ARCHITECT'S SUPPLEMENTAL INSTRUCTION NO. 5

DATE: February 19, 2024 **PROJECT NO:** 230117

RE: Streets of West Pryor – Lot 5 Core & Shell

FILEPATH: C:\Users\ross\OneDrive - Scherdt Design Group\Documents\230117 SOWP Lot 5 Core - Shell_AS+FOUR_rjz\HC2.rvt
DATE: 11/7/2023 10:33:50 AM
DRAWN BY: Author

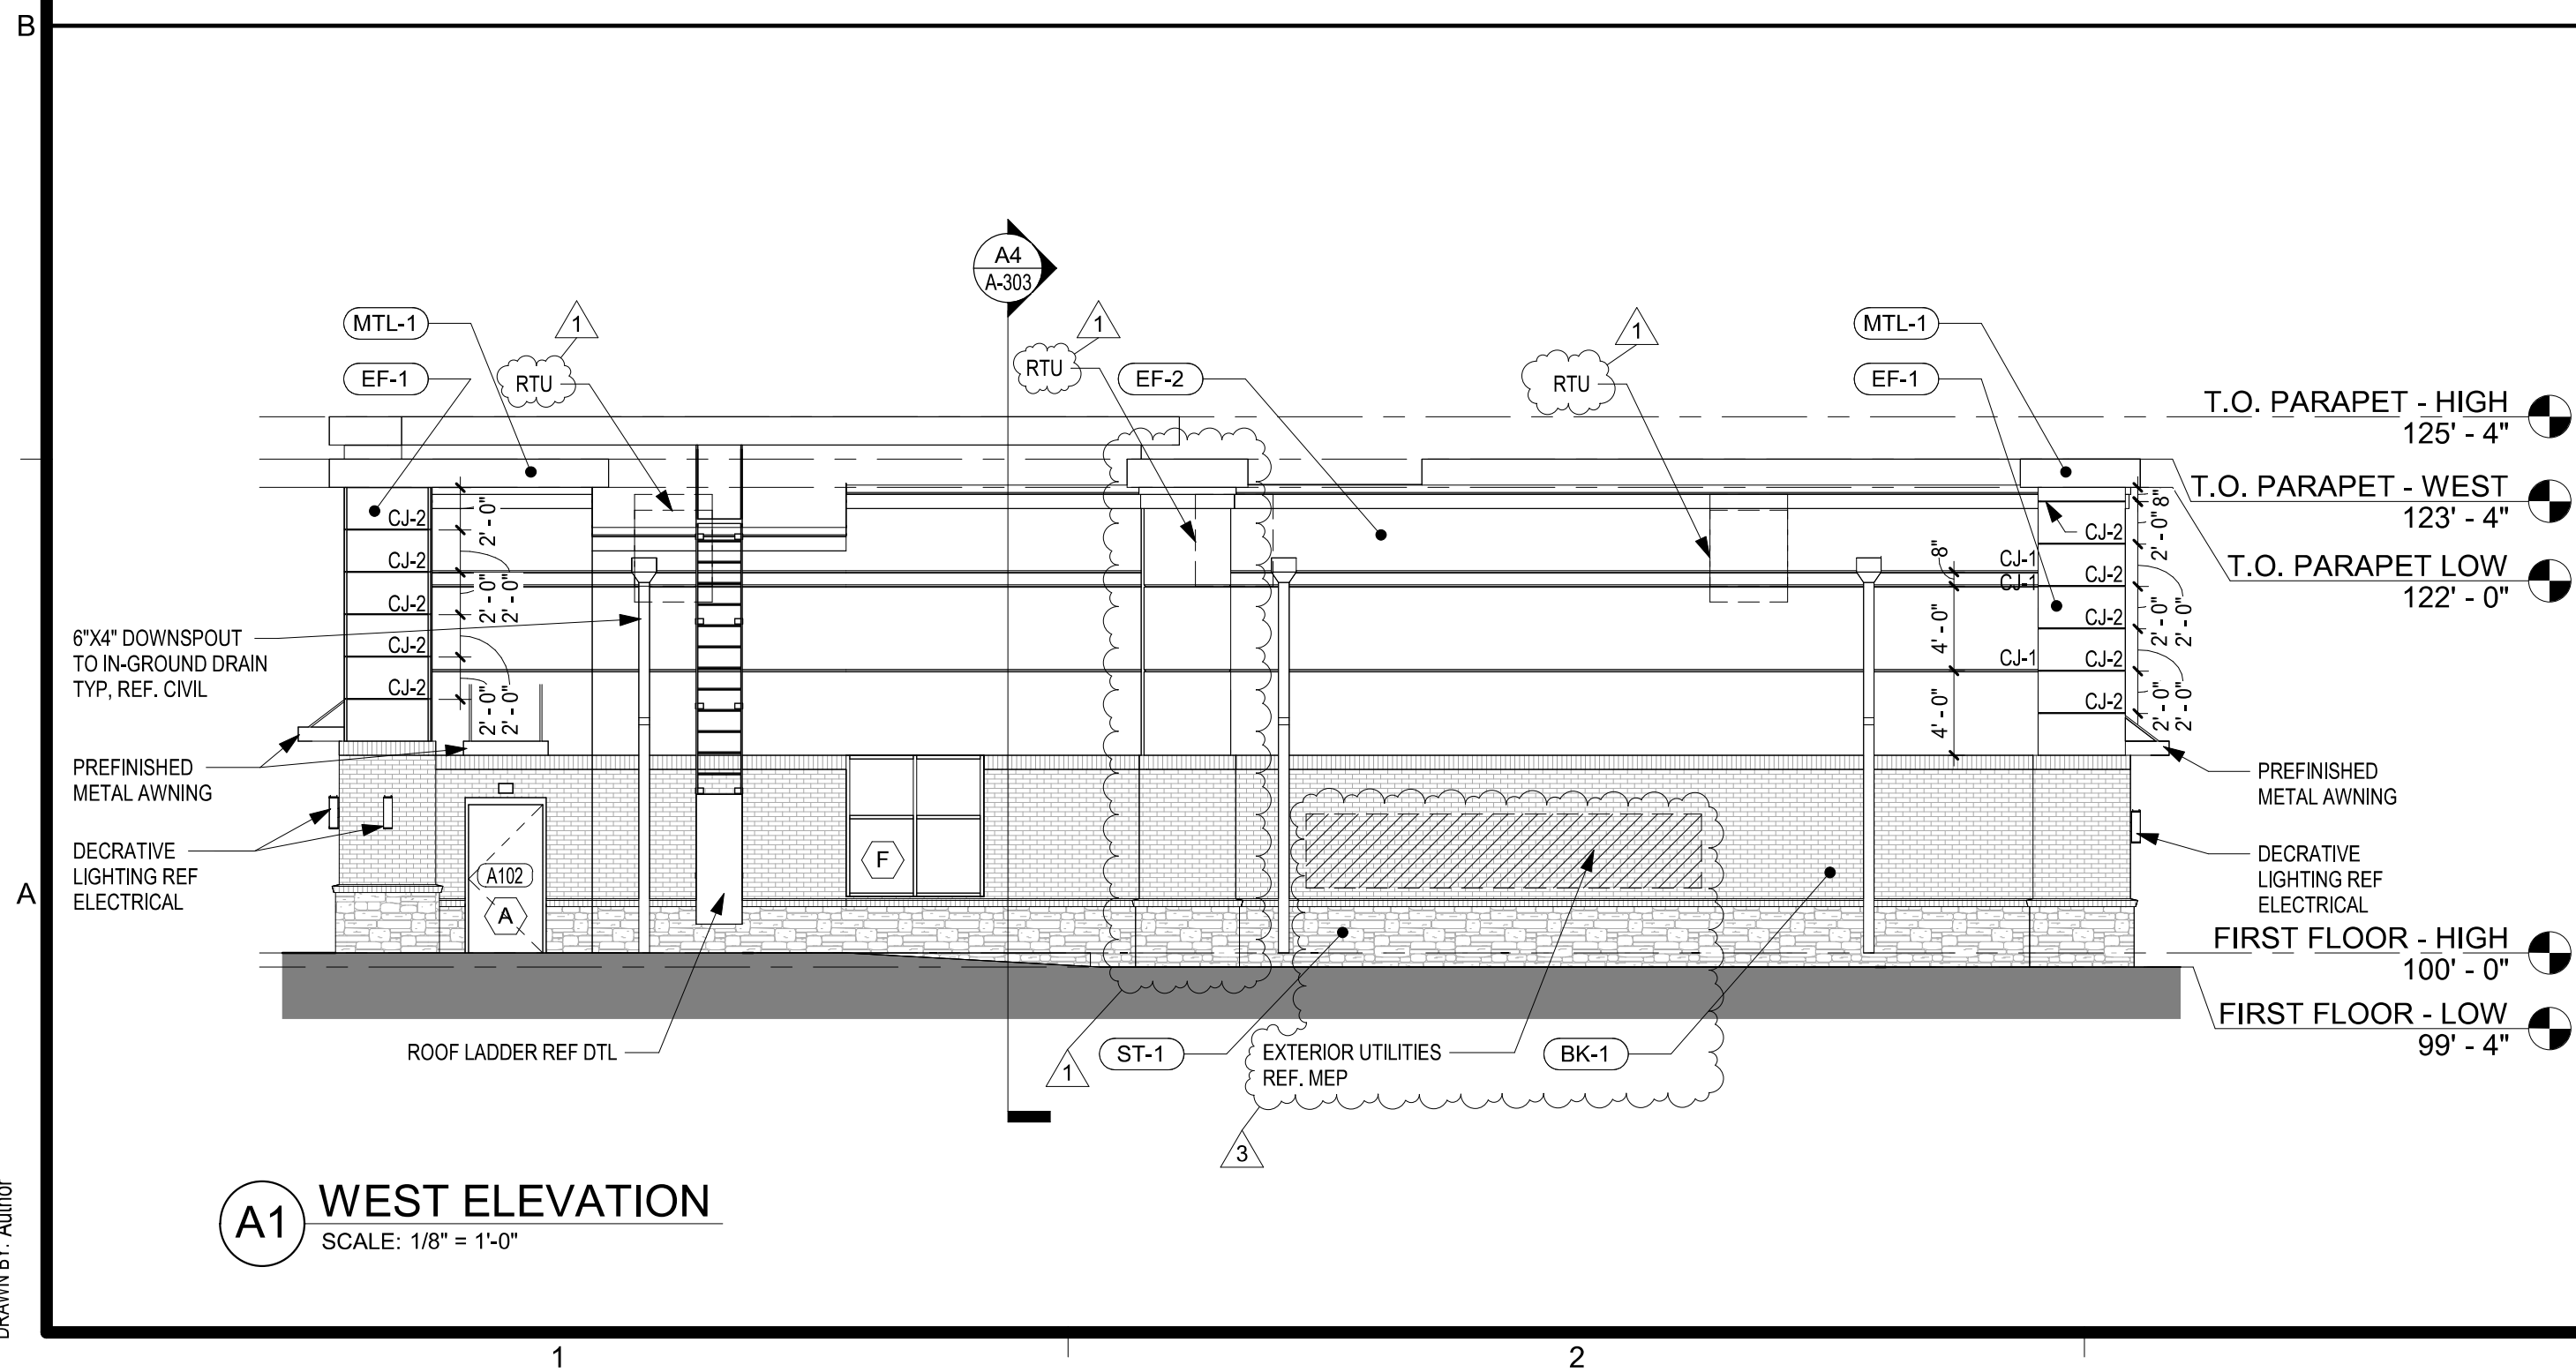
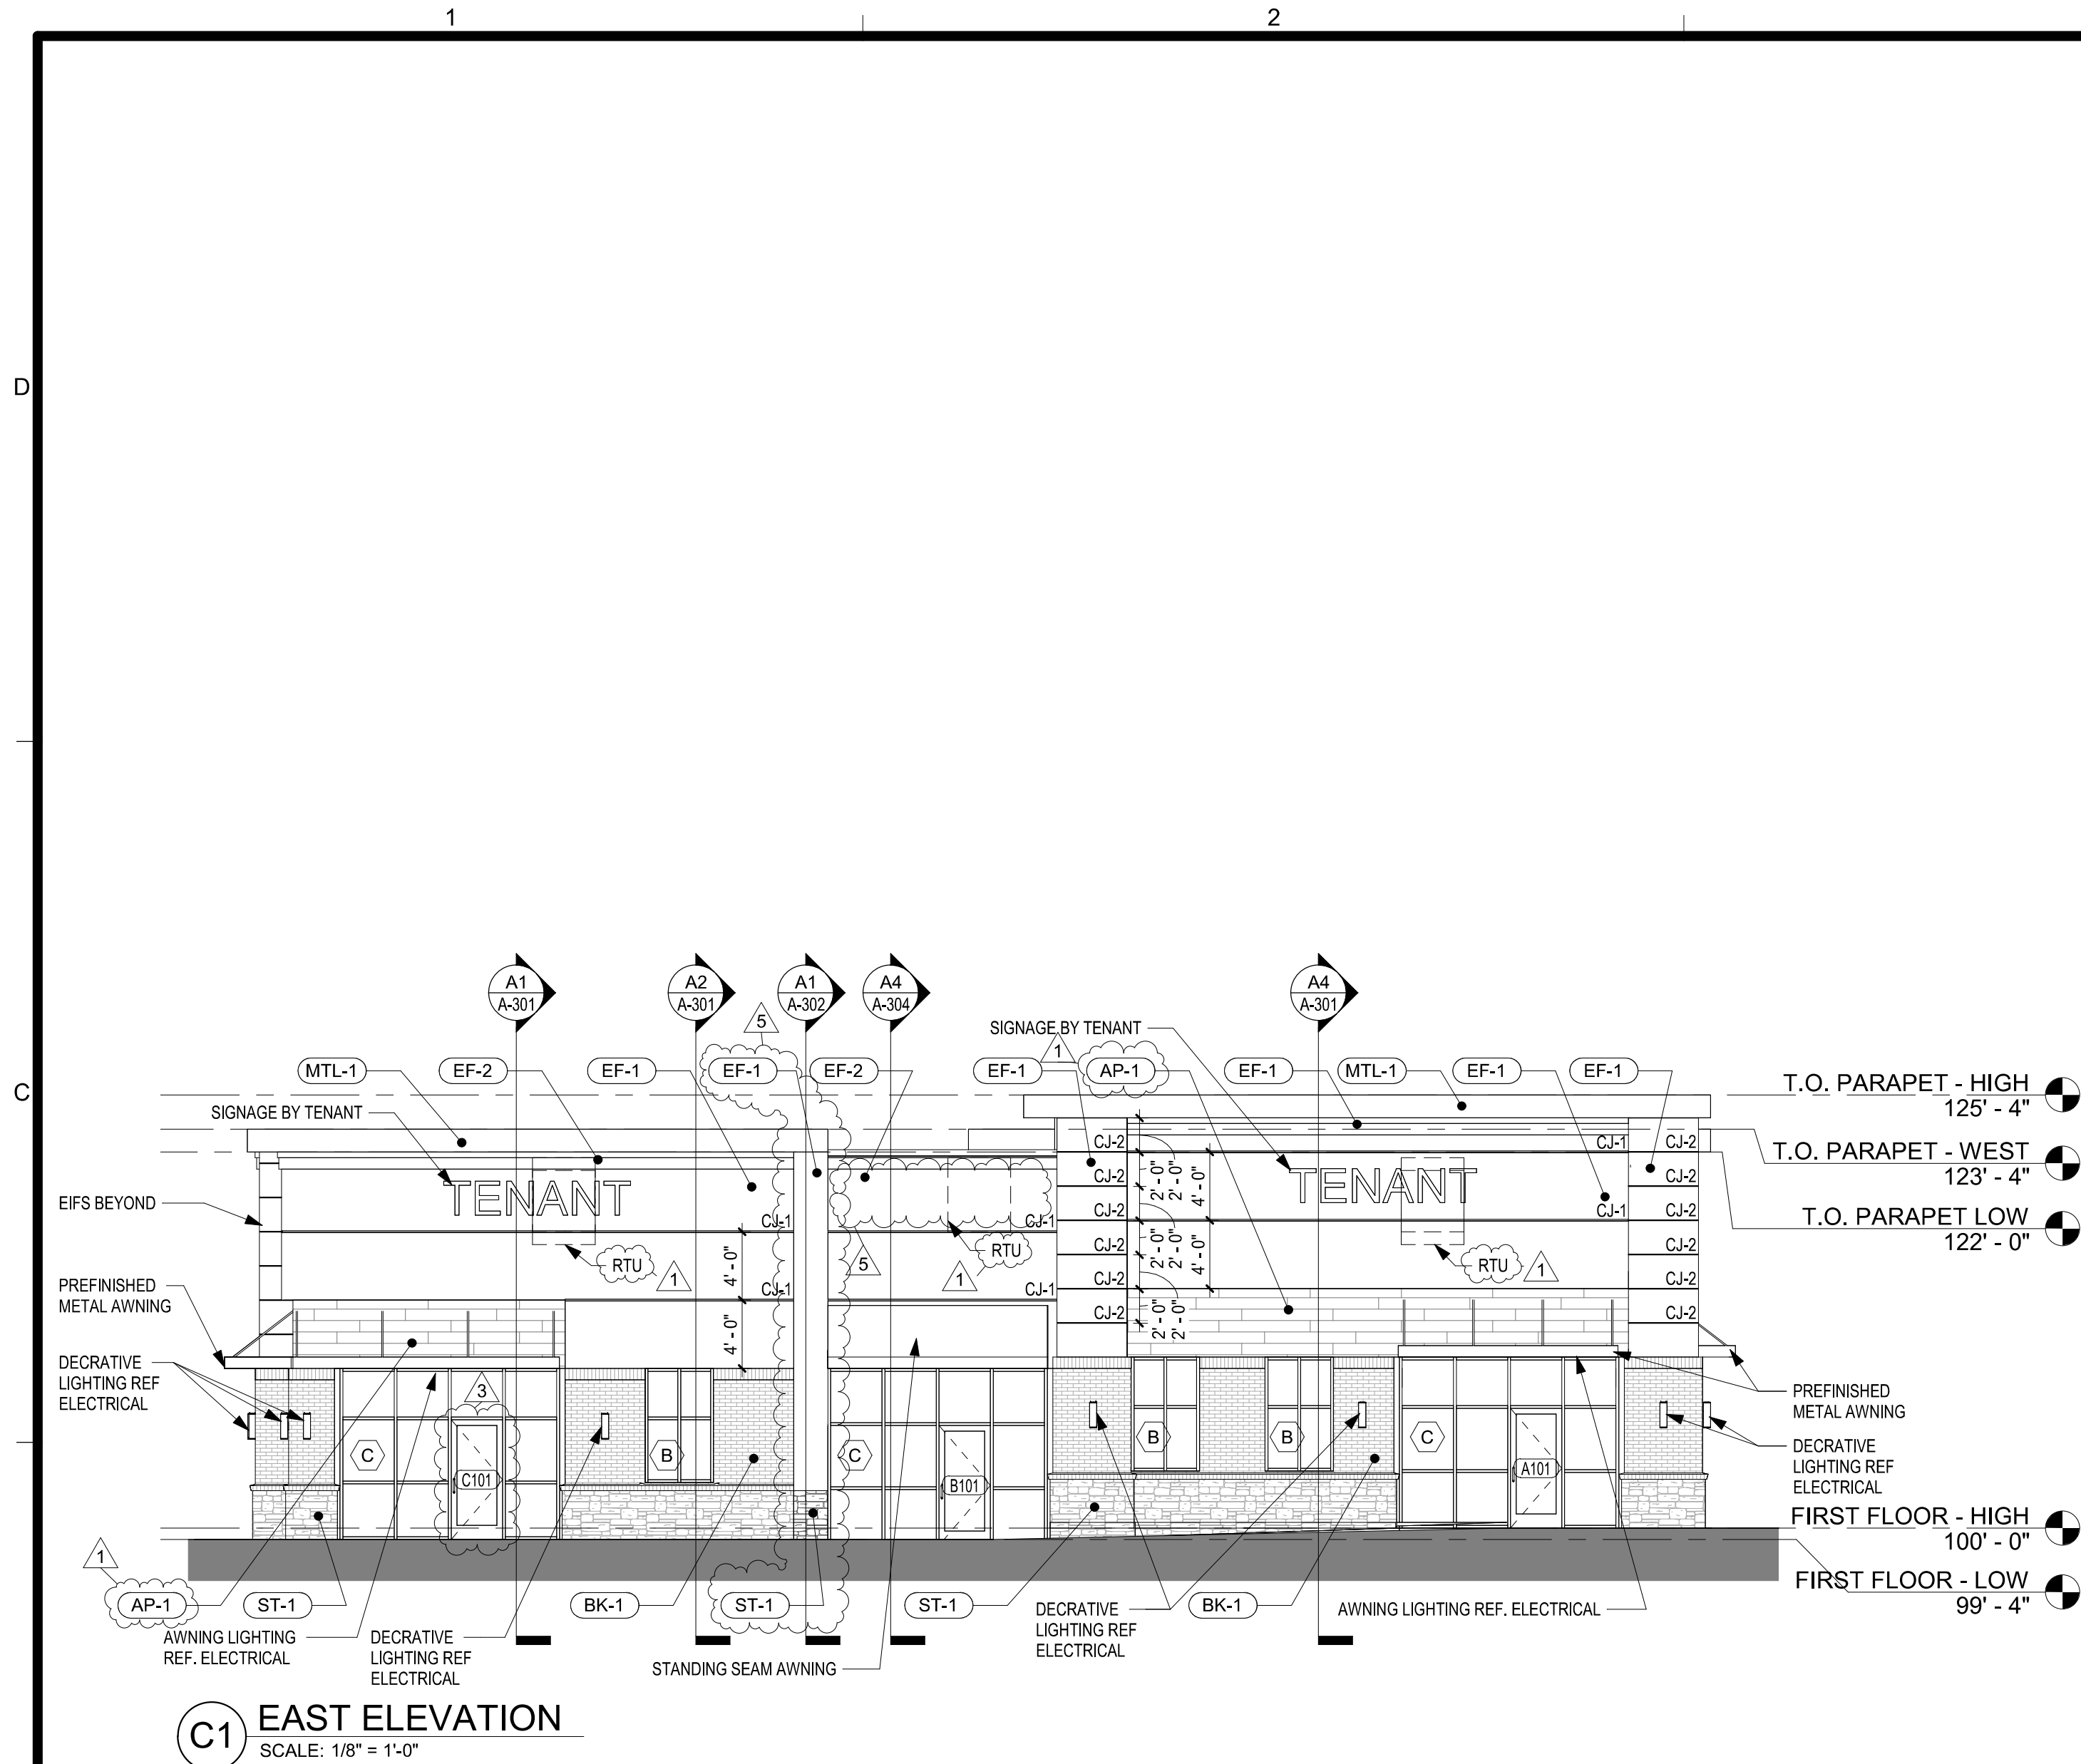
- A-1 Sheet G-001 – Code summary updated with usable square foot occupant load calculations and exit requirements for tenant suites A, B & C.
 - A-1.1 Sheet G-001 – Code plan updated with occupant load calculations and egress width for tenant suites A, B & C.
- A-2 Sheet A-101 – Two hour rated demising wall added to full East to West length of the building spaced 21 feet from face of gypsum board to the other second two hour rated demising wall. Creating and dividing the Core & Shell building into now three separate tenant suites.
 - A-1.A Updating tenant suite designations as Suite A, B & C respectively.
 - A-1.B Updating tenant suite square footage.
- A-3 Sheet A-102 – Roof Top Unit added to service enlarged Tenant Suite B space.

SHEET NUMBER S-001

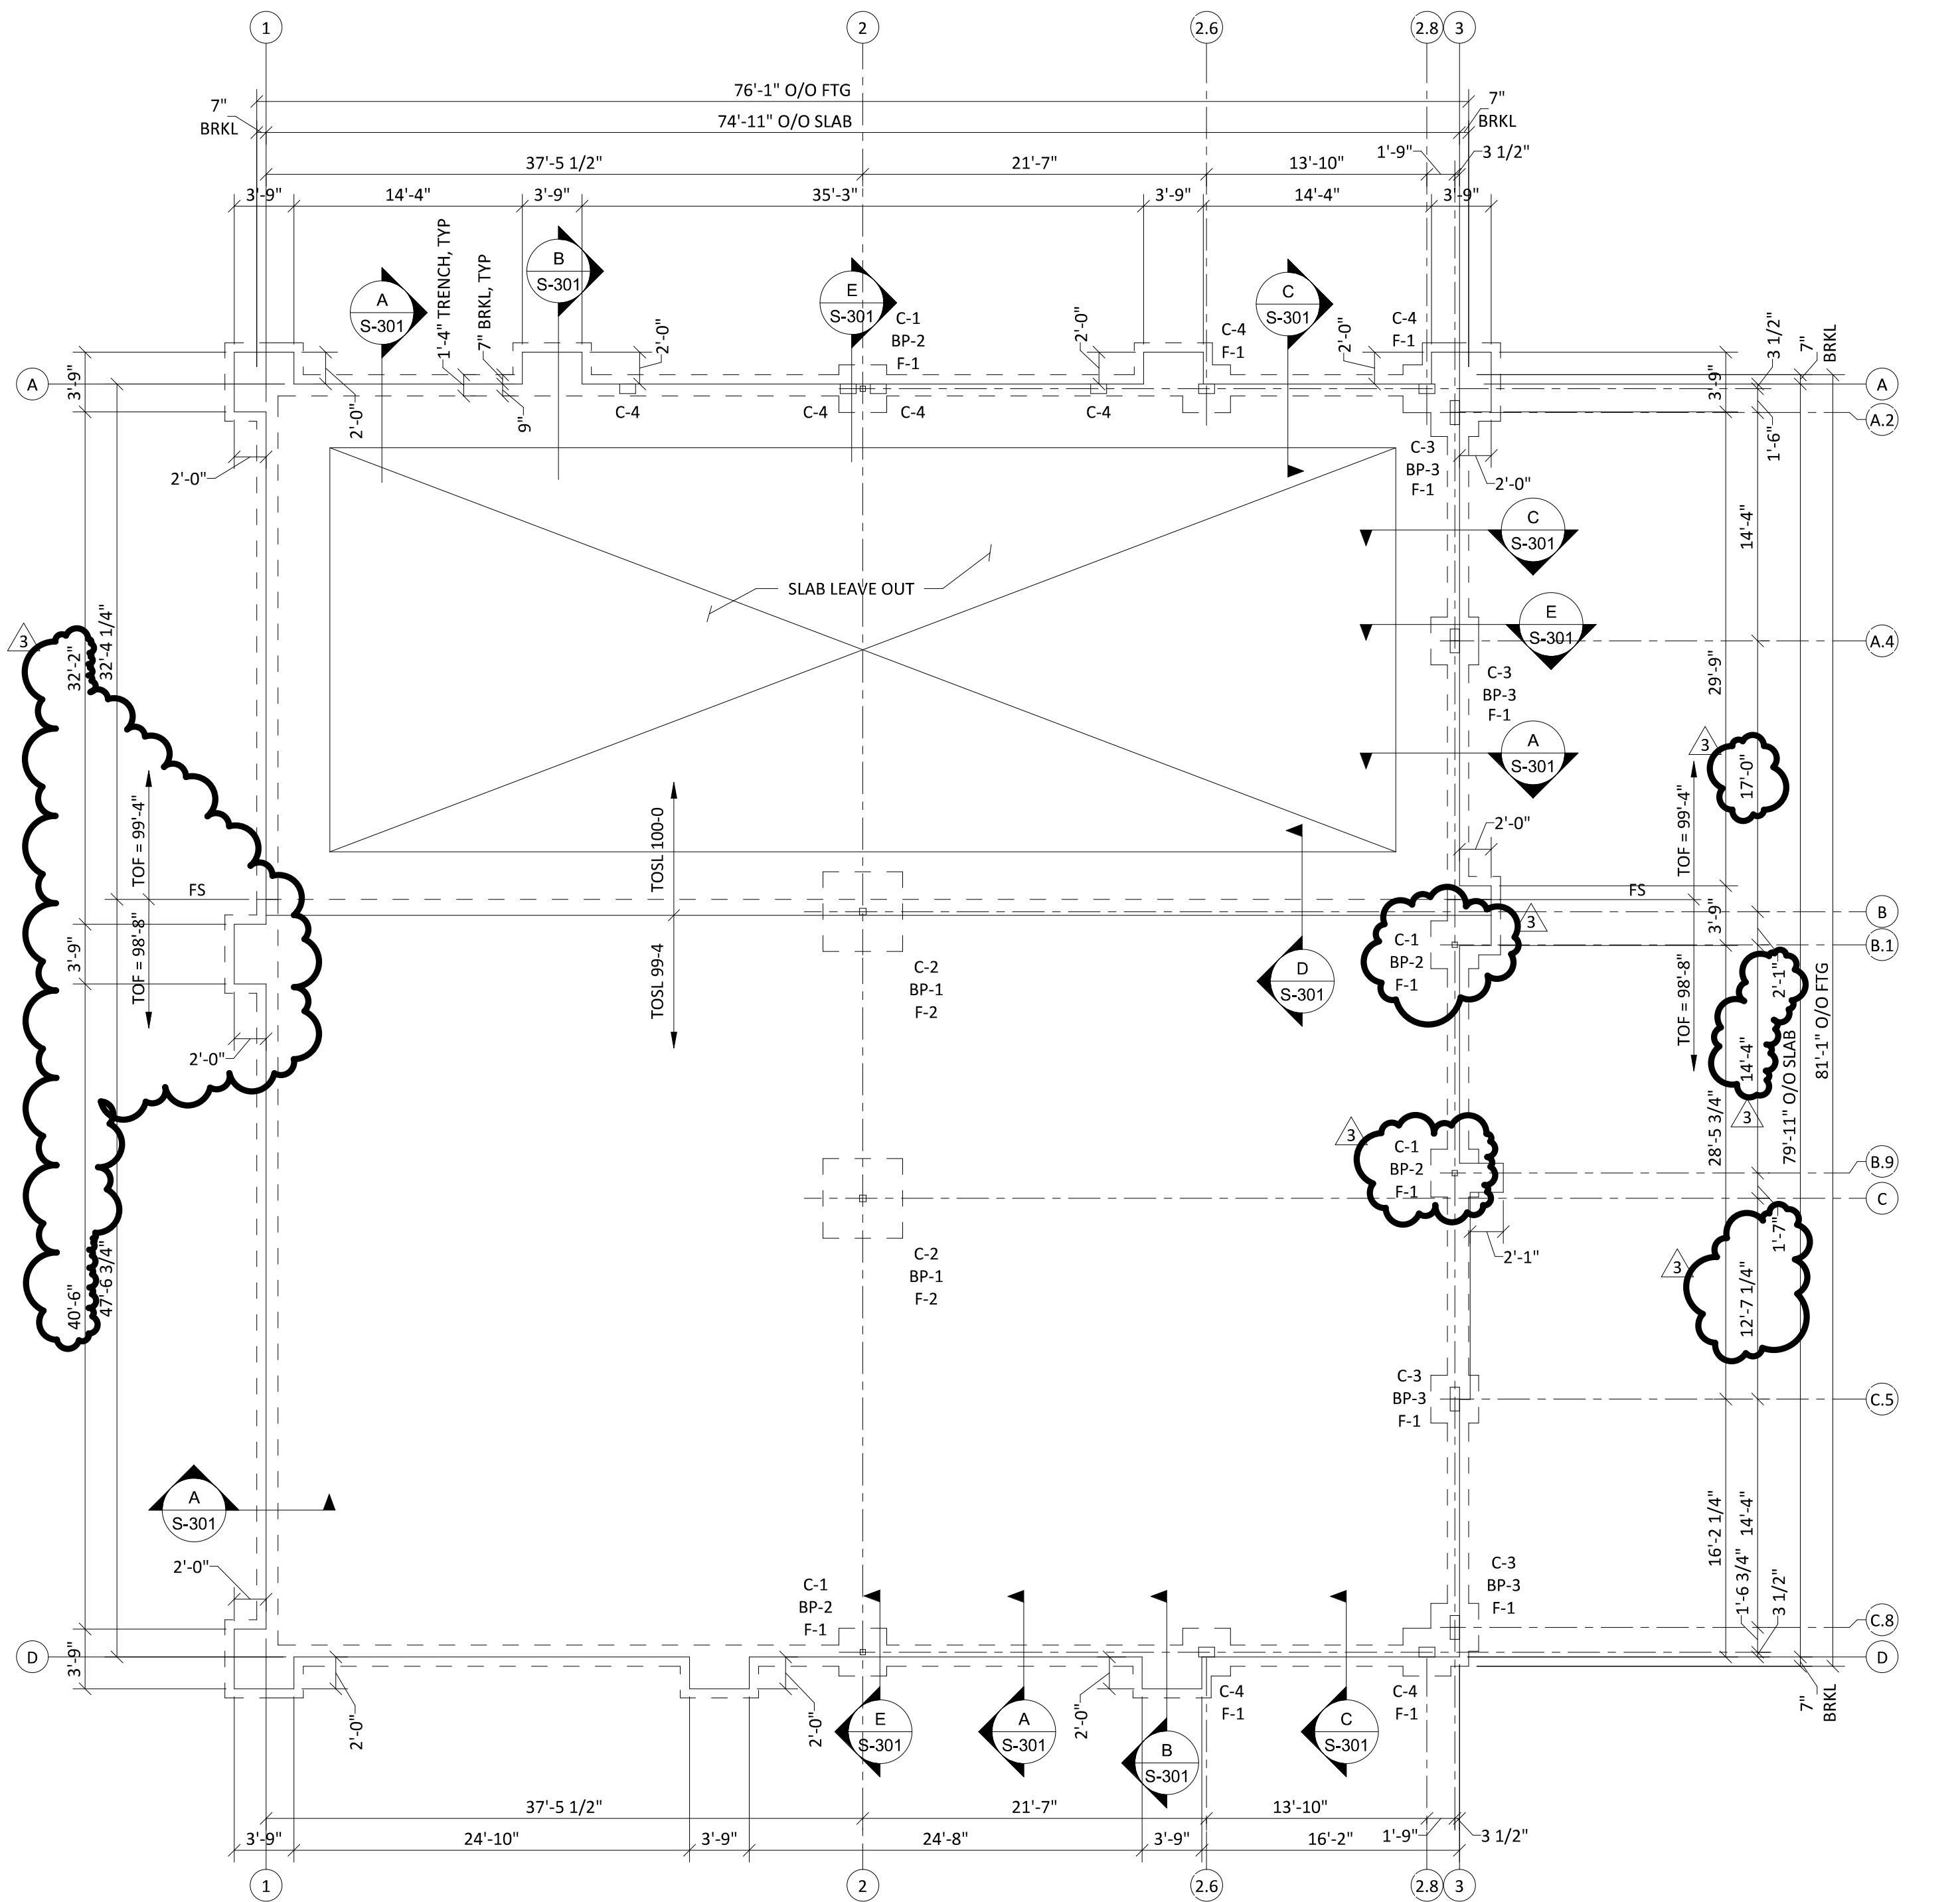
- S-1 Sheet S-001 – Updates to general notes Risk Category and Wind Load information.
- S-2 Sheet S-101 – Foundation updates to columns B.1-3 & B.9-3 and dimensional spacing on East.
 - S-2.A – Addition of West pilaster foundation.
- S-3 Sheet S-102 – Future pass-through openings added to shearwall
 - S-3.A - Wood shearwall schedule updated.
 - S-3.B – Addition of West wall pilaster.
- S-4 Sheet S-103 – RTUs rotated 90 degrees for structural support.
 - S-4.A – Future pass through openings located in shearwall.
 - S-4.B – Addition of West wall pilaster.
- S-5 Sheet S-201 – Updated shearwall pass-through openings and west wall pilaster added to isometric.
- S-6 Sheet S-301 – Bolt type and dimensional location update to Baseplate Details drawings BP-2.
